Appendix MA: Design and Access Statement (DAS)

Environmental Statement Addendum

Transport for London

Introduction to the Addendum

Figure 4.26A Kennington Park - Massing Studies (supplementary to Figure 4.26)

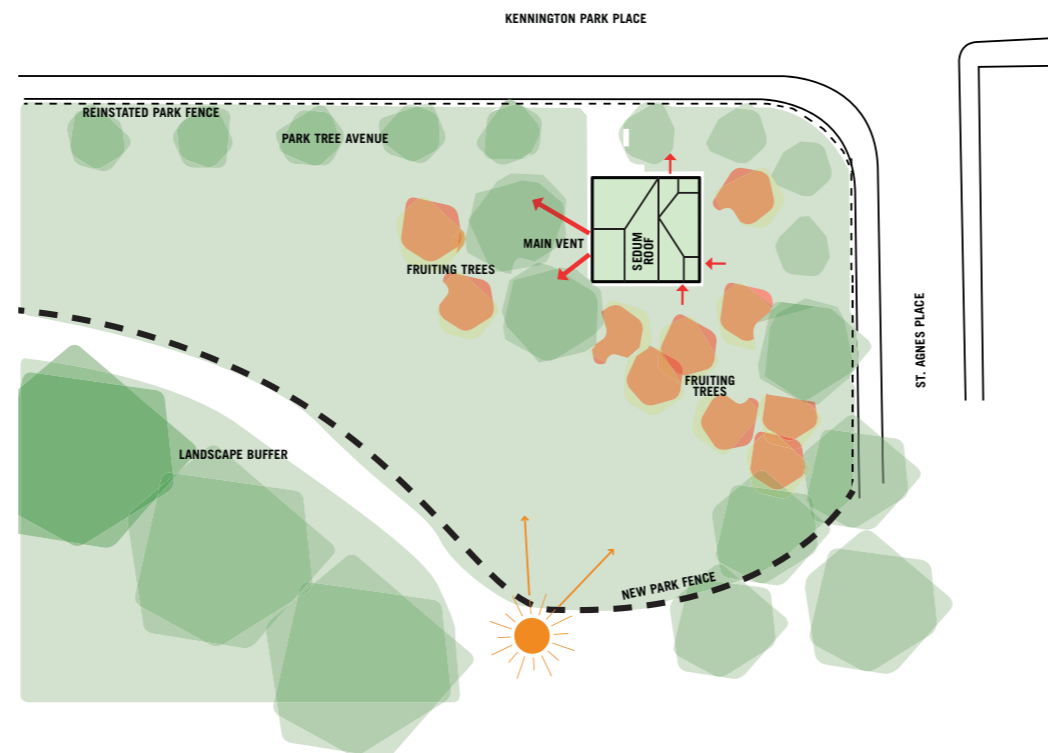
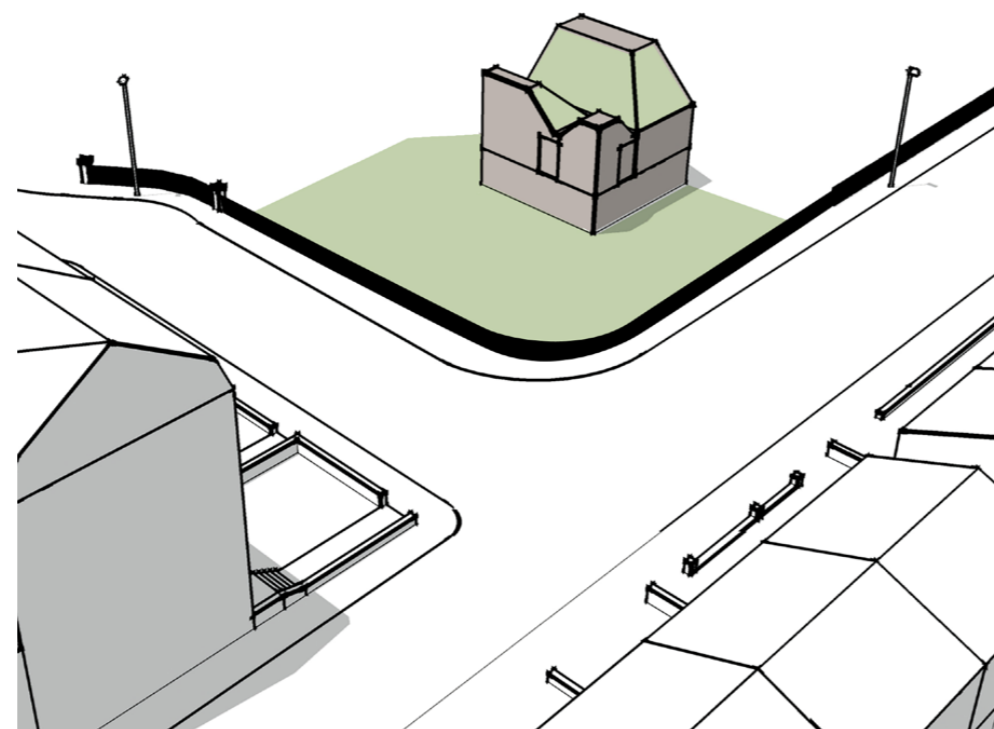
- 4.5.21 A *Although the community building has now been removed from the scheme following further consultation with LB Lambeth and LB Southwark, the design and location of the head house remains the same as submitted and its concept as a 'pavilion in the park' still stands, as shown in Figure 4.26A.*

Figure 4.26A supplements Figure 4.26 Kennington Park – Massing Studies.

Figure 4.27A Kennington Park - Proposed Layout of the Head House

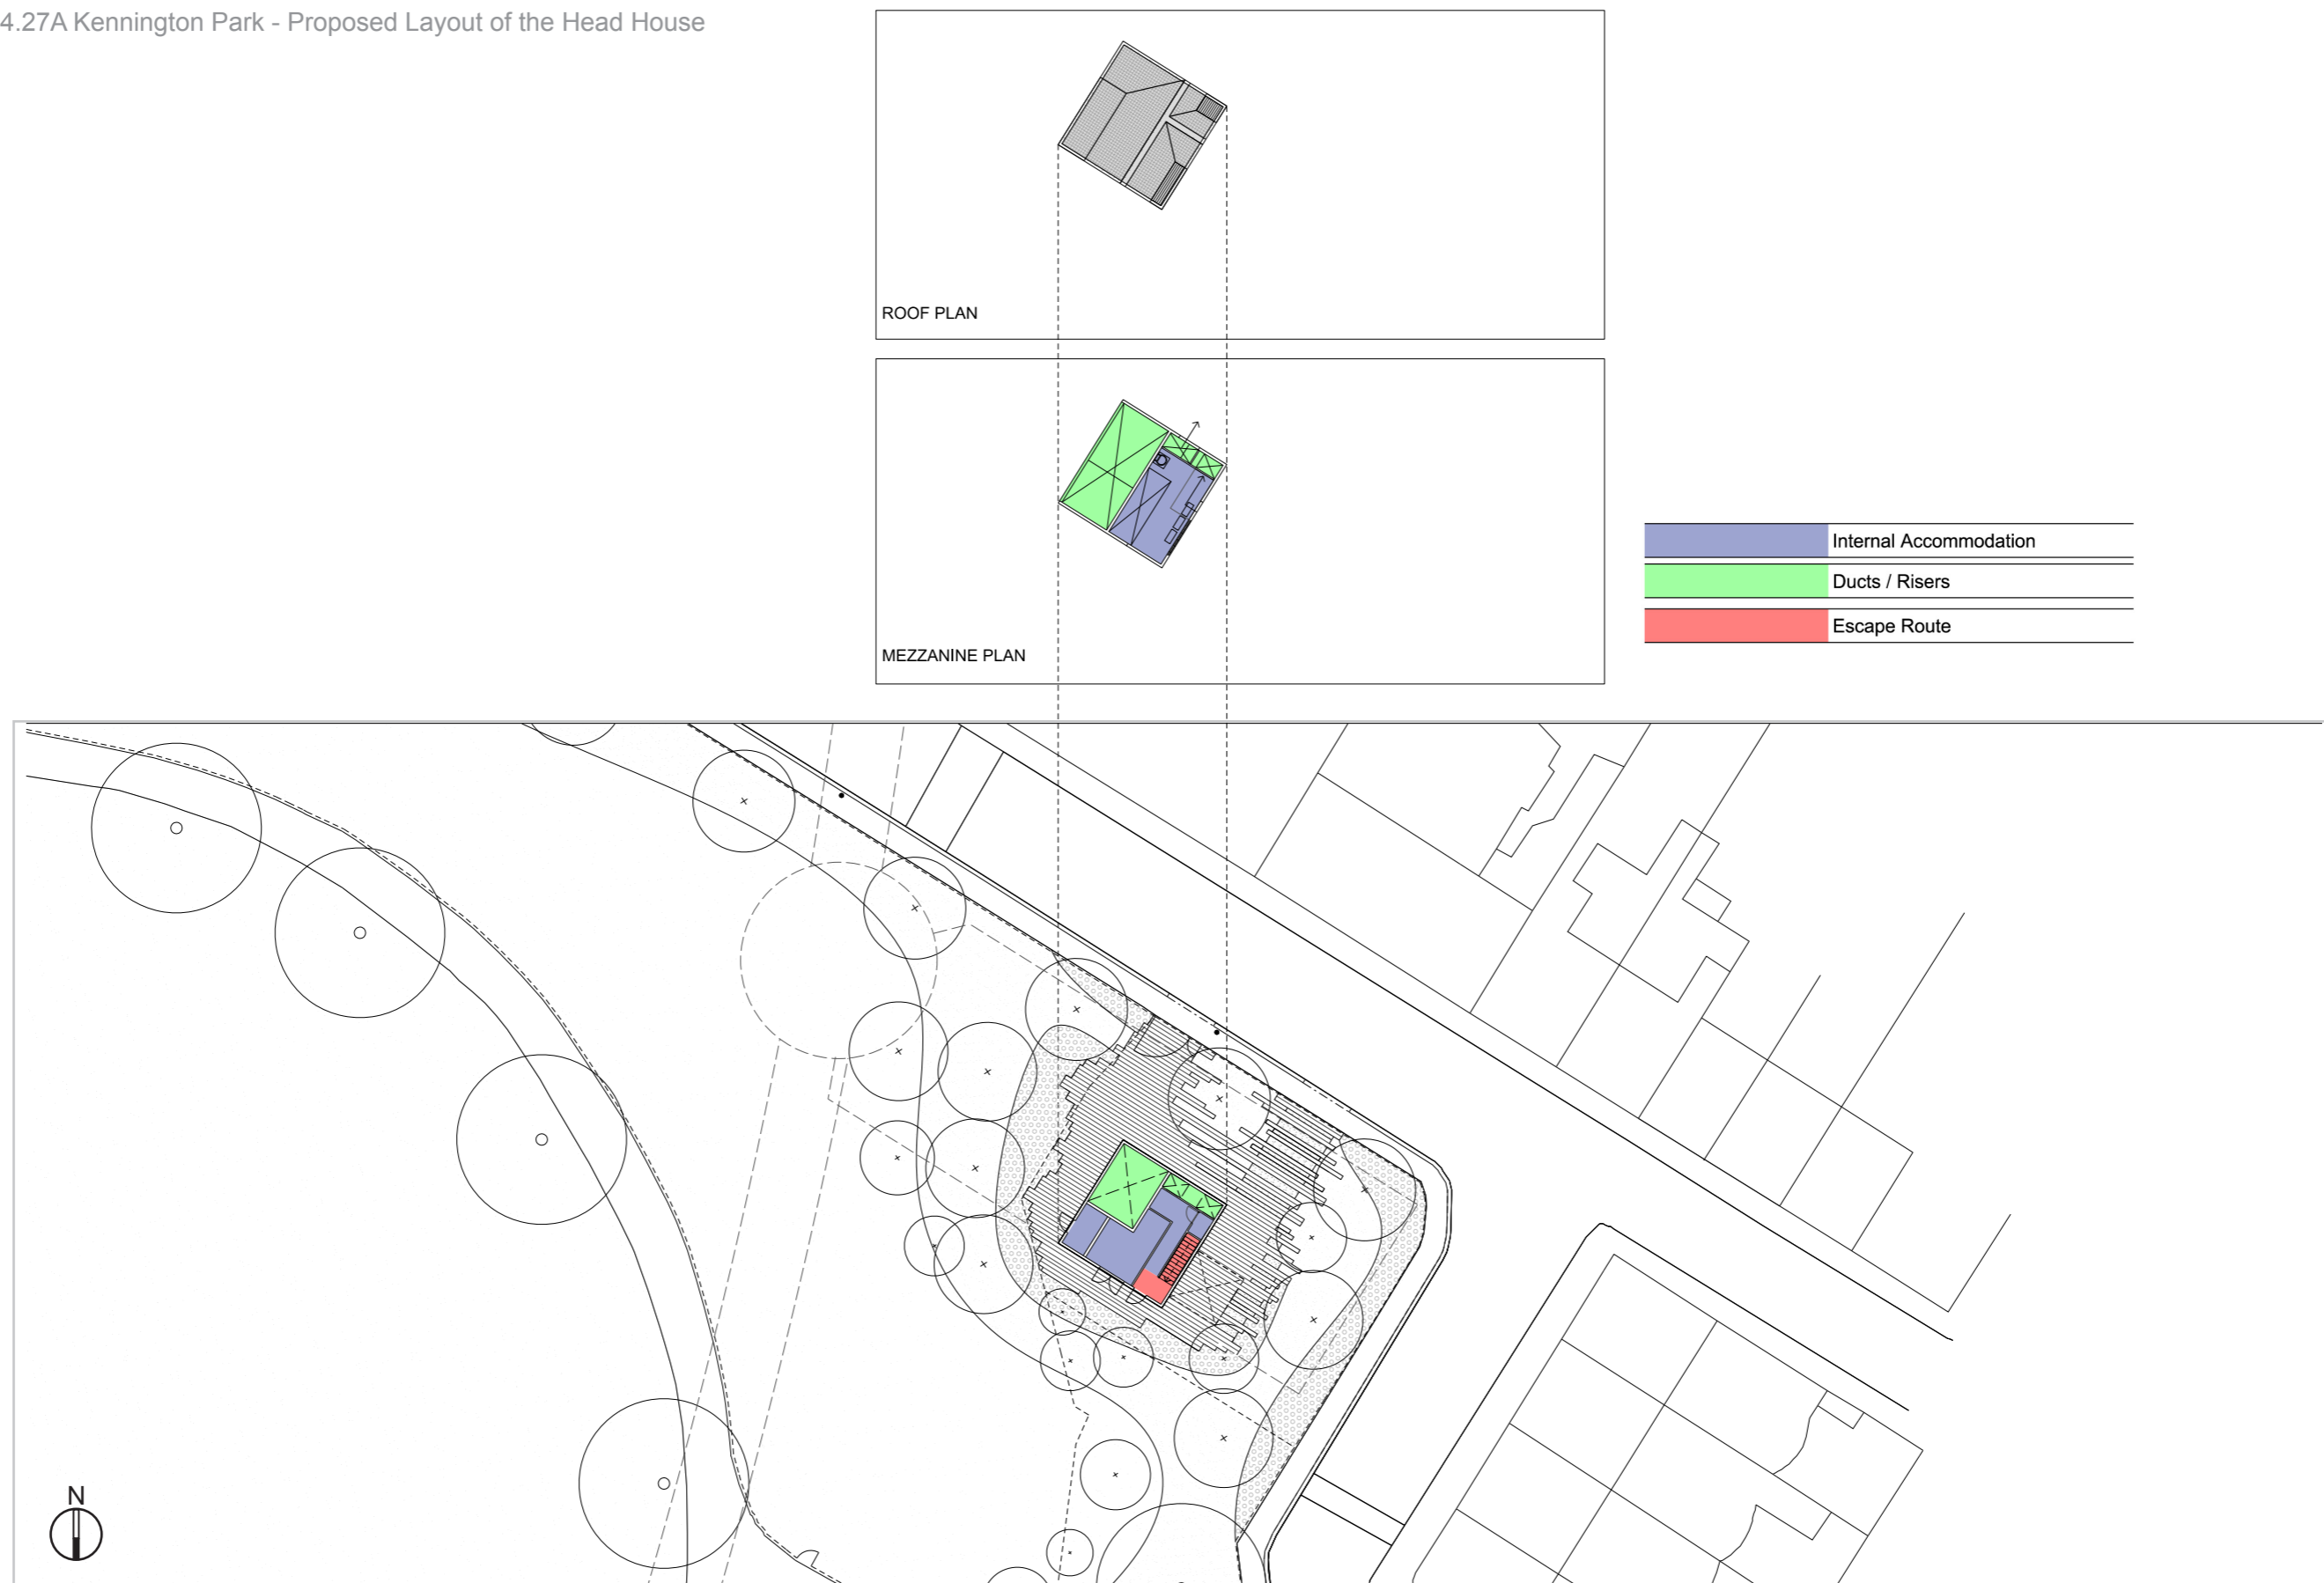
4.5.25 *The concept is to locate the head house and community buildings within part of the existing fenced off area in the north east corner of the park and to reduce their its visual impact on the park and neighbouring listed properties. The proposed head house building and landscape is shown in Figure 4.27A.* *The proposals for the buildings and landscape seeks to reflect the sensitive setting of the site, whilst also providing wider views into the park.*

Figure 4.27 Kennington Park – Proposed Layout of the Head House and Community Building has been replaced with Figure 4.27A Kennington Park – Proposed Layout of the Head House.
